Subject: **Bid #: 7946-W3, Green Hill Park Community Garden / DPWP**

### **ADDENDUM NO. 2**

**Project:** Bid No. 7946-W3 **Greenhill Park Community Garden**  
**City of Worcester Department of Public Works and Parks**  
**Parks, Recreation and Cemetery Division**

**General Bid Clarification**

**L140**

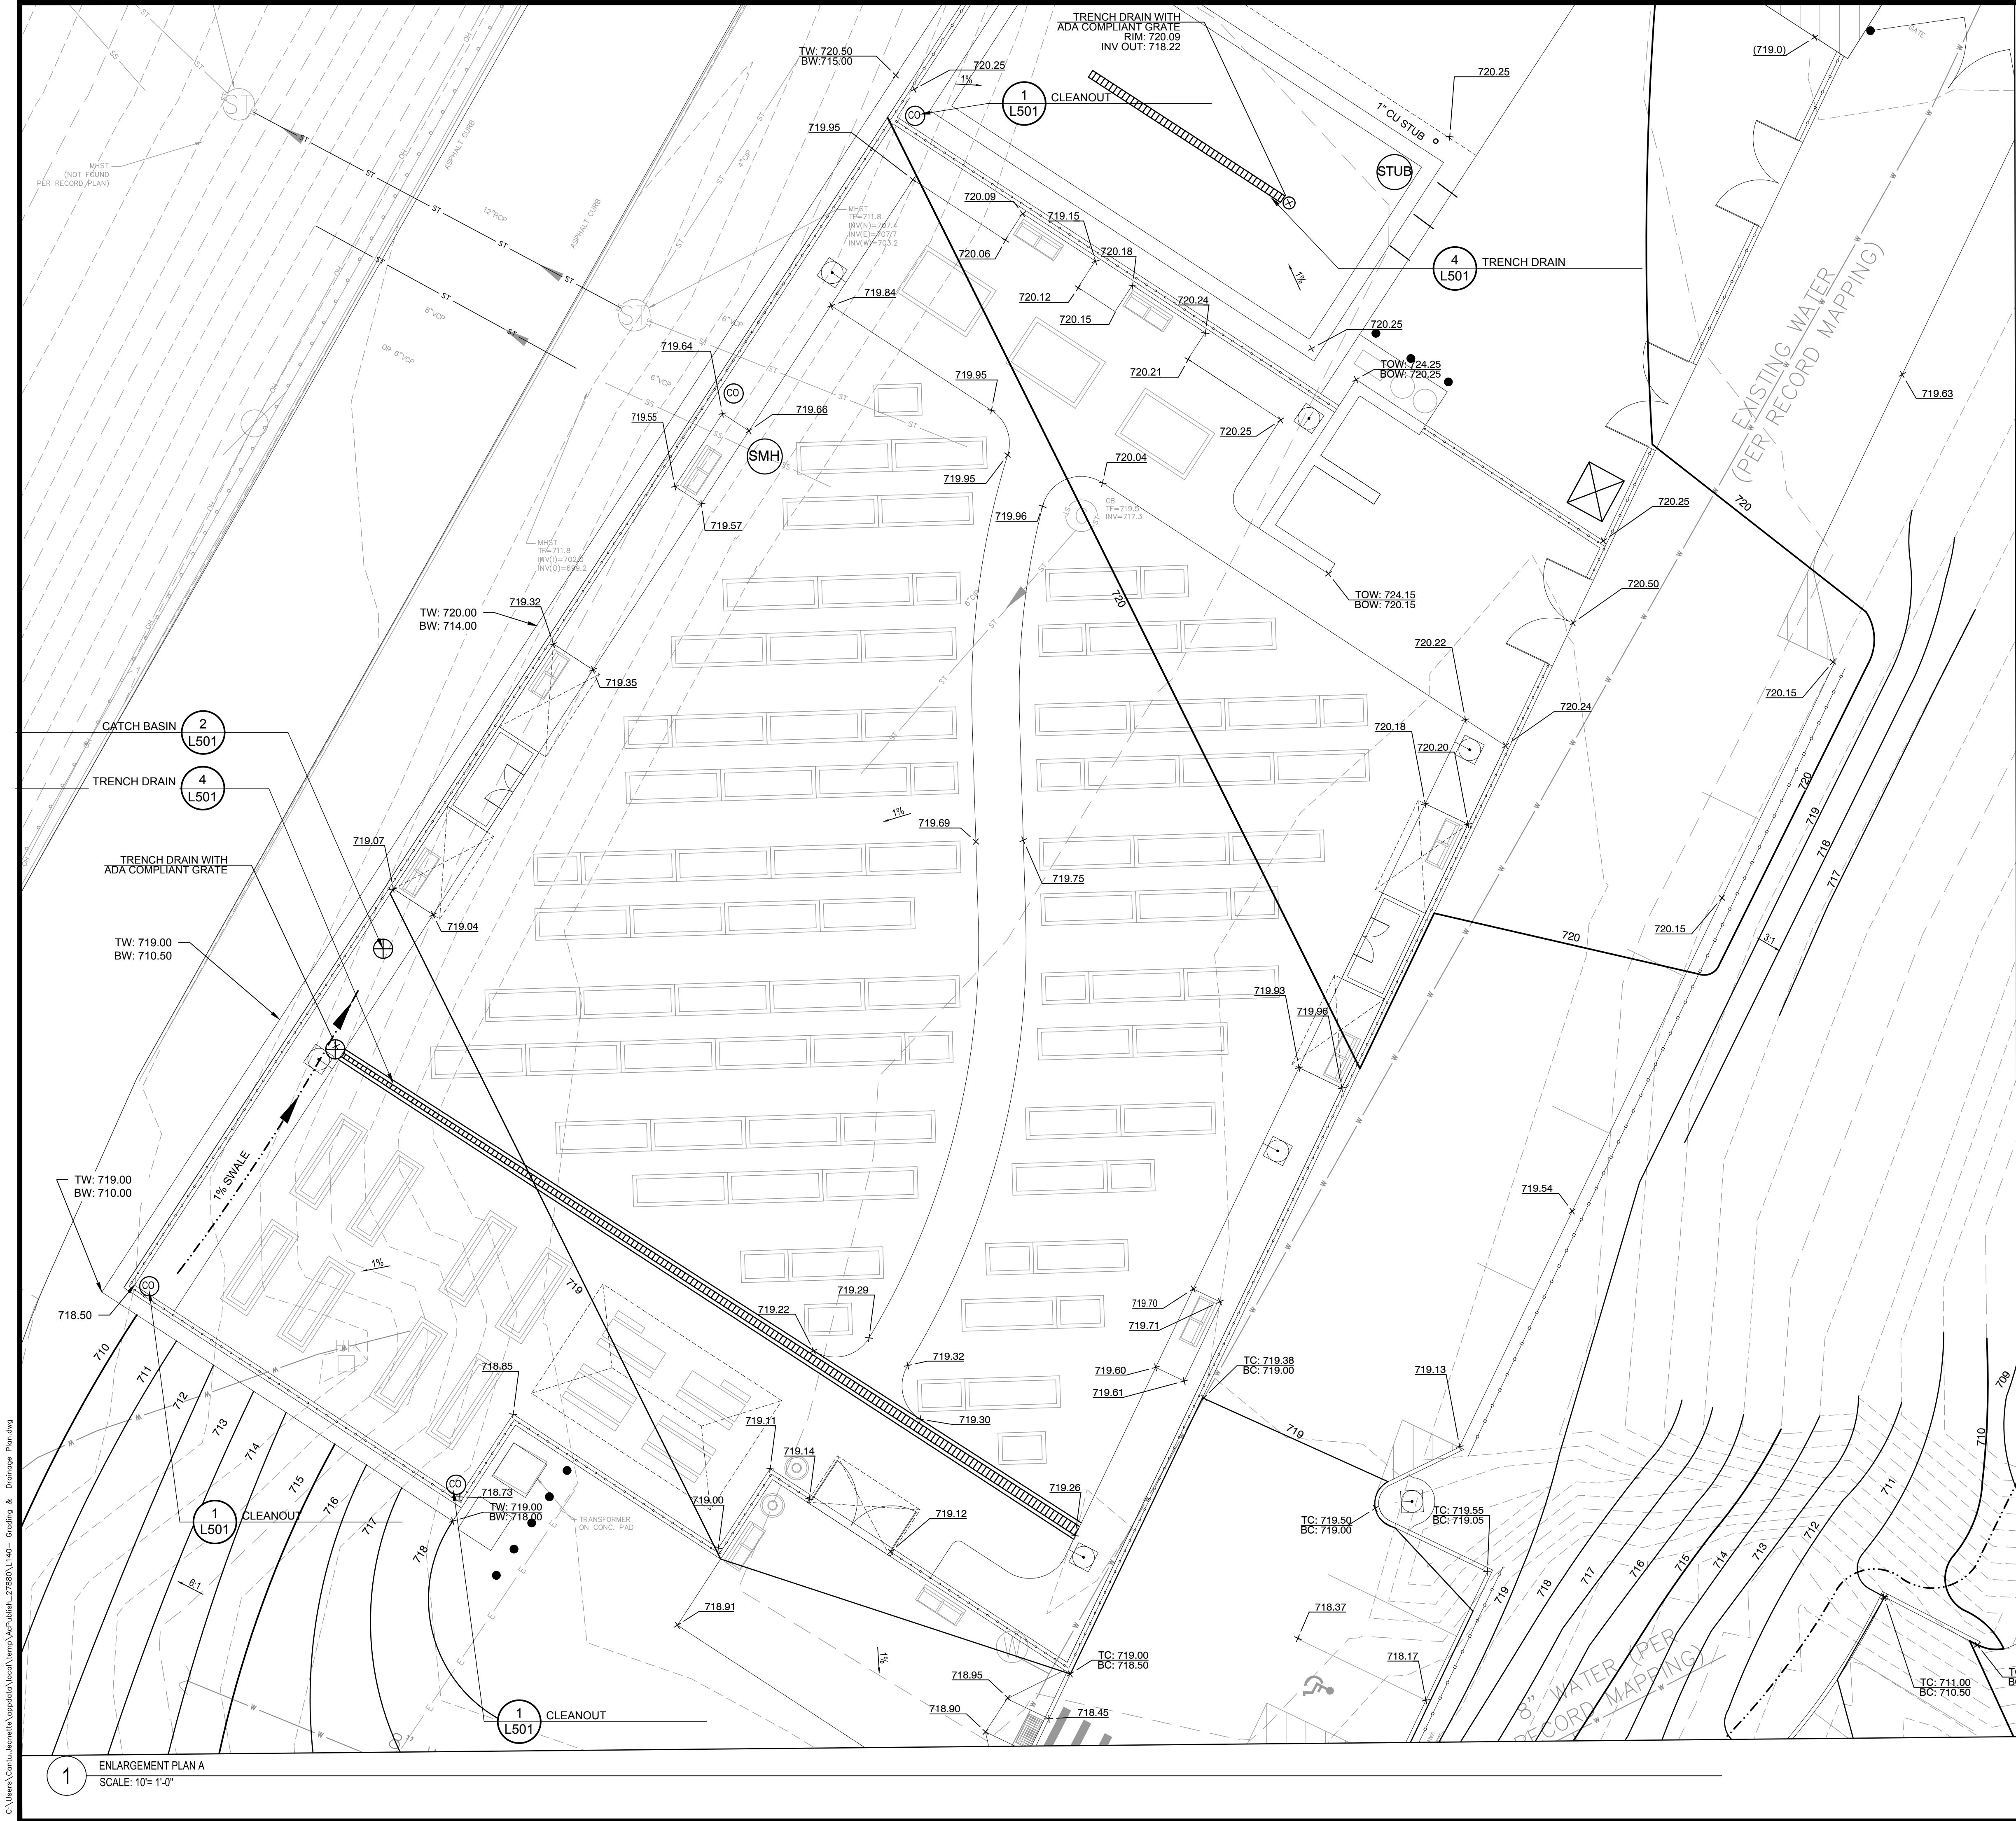
Question 24: *The grading plan on Sheet L140 shows an approximate 12'+ excavation adjacent to the existing wood framed building for the construction of the new driveway and retaining wall. Please confirm this is the intent. Will the building need to be supported by the Contractor during excavation? Is there any work required to this structure? If so, can existing drawings of this structure be provided?*

**Answer 24:** Yes, the excavation adjacent to the existing building is the intent. There is no work required for the support of the building. The contractor shall pause excavation and notify the owner and engineer of any unknown conditions of this area.
